Proposal for Supplement 3 to the 01 series of amendments to Regulation No. 129

Submitted by the expert from France*

The text reproduced below was prepared by the expert from France, on behalf of the informal group on Child Restraints Systems and updates the latest version of Regulation No. 129. The modifications to the current text of the Regulation are marked in bold for new or strikethrough for deleted characters. **This document supersedes ECE/TRANS/WP.29/GRSP/2017/15. It includes all proposals of modifications made by the IWG ECRS during the three last meetings (2017/01/25, 2017/03/09 and 2017/04/19)**

Figure 2
Arrangement for testing a rearward-facing device, not supported by the dashboard

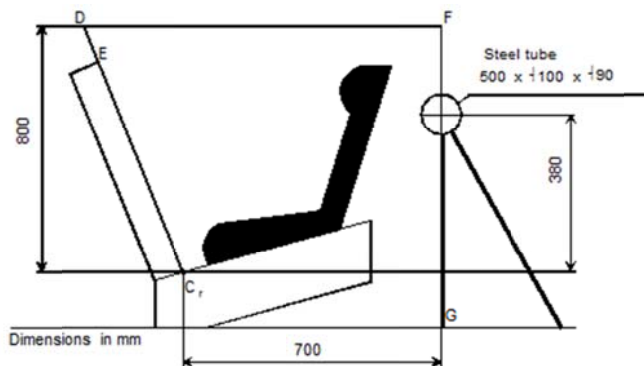
6.6.4.1.2.1. Head excursion: no part of the head of the dummy shall pass beyond the planes FD, FG and DE, as shown in figure 2 below. This shall be judged up to 300 ms or the moment that the dummy has come to a definitive standstill whatever occurs first.

Except when testing using Q6 dummy where:

- a) The value in relation to the FD plane is 840 mm

Where a test is conducted with paragraph 6.6.4.1.6.2. or paragraph 6.6.4.1.8.2. above, only the second configuration test results without 100 mm diameter bar will be considered.

Method of defining head impact area of devices with backrests **or impact shields** and for rearward-facing devices defining the minimum size of side wings

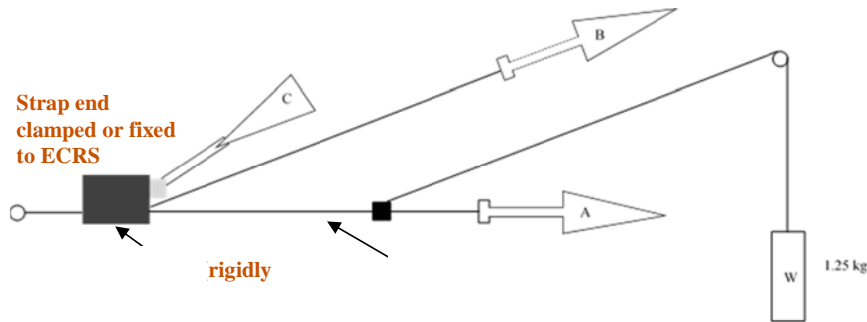
1. **Head impact area**
 - 1.1. **Definition of backrest head impact area**

Place the device on the test bench described in....
 - 1.2. **Definition of impact shield head impact area**

The impact shield head impact area is the whole upper surface of the impact shield, which comprises any surfaces visible from the top, looking down on the shield."

Figure 1.

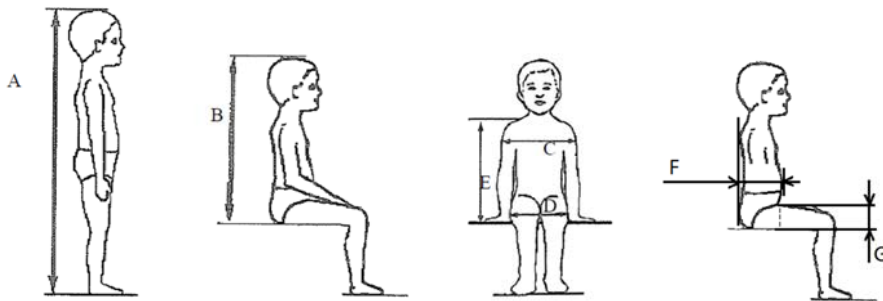
All lateral dimensions are measured under a contact force of 50 N with the devices described in Figure 2 & Figure 3 of this annex and the following tolerances will be applied:

Minimum Sitting height:

- up to 87 cm B - 5 per cent

- From stature from 87 cm and up to 150 cm B - 10 per cent,

Minimum shoulder height (5 percentile): $E1_{-2}^{+0}$ cm

Maximum shoulder height (95 percentile): $E2_{-0}^{+2}$ cm

The mass of the devices described in Figure 2 & Figure 3 of this annex shall be 10 kg +/- 1 kg

Figure 2: *ECRS Measurement Device*
Side and Front View of the measuring device

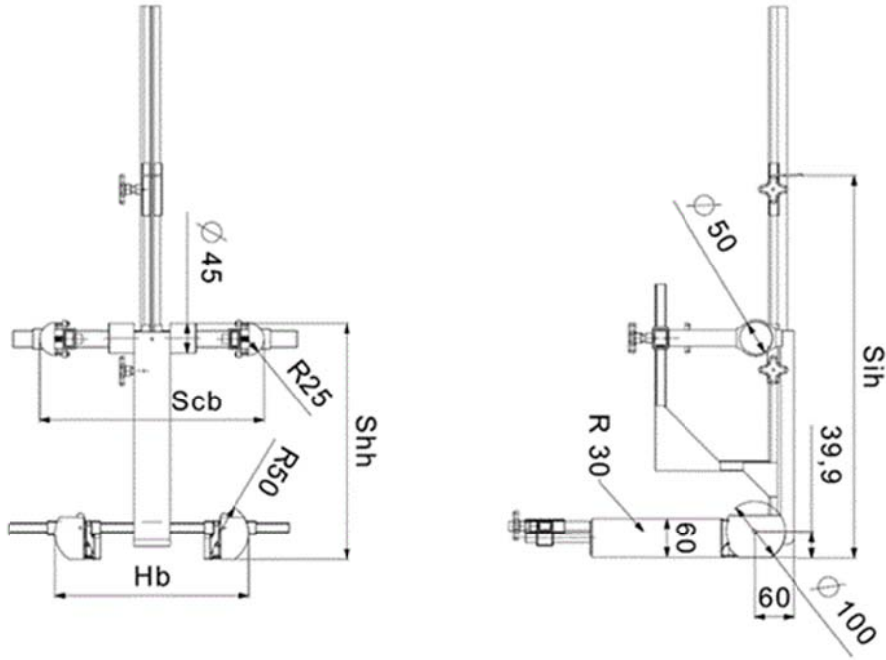
- *For any removable insert (e.g. for use as described by manufacturer's instructions)*
- *For each occupant restraint method (e.g. harness & shield)*
The internal geometry assessment should be conducted with the ECRS placed on a flat surface or connected to a base in the case of ECRS modules.
For integral or non-integral ECRS the device shown in Annex 18, Figure 2 shall be used.
For ECRS with an impact shield the device shown in Annex 18, Figure 3 shall be used.

Side and Front View of the measuring device for measurements applicable to Enhanced Child Restraint Systems that feature an impact shield

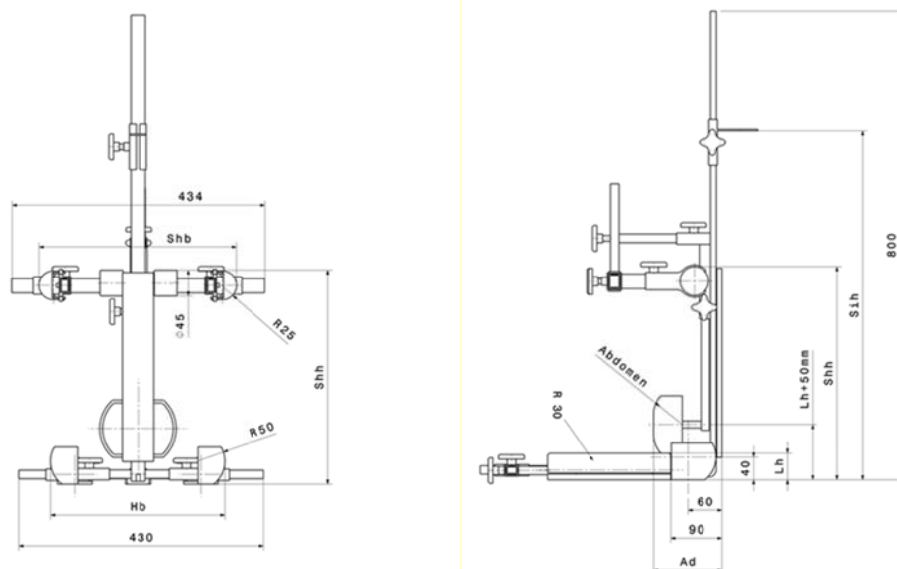
Figure 3
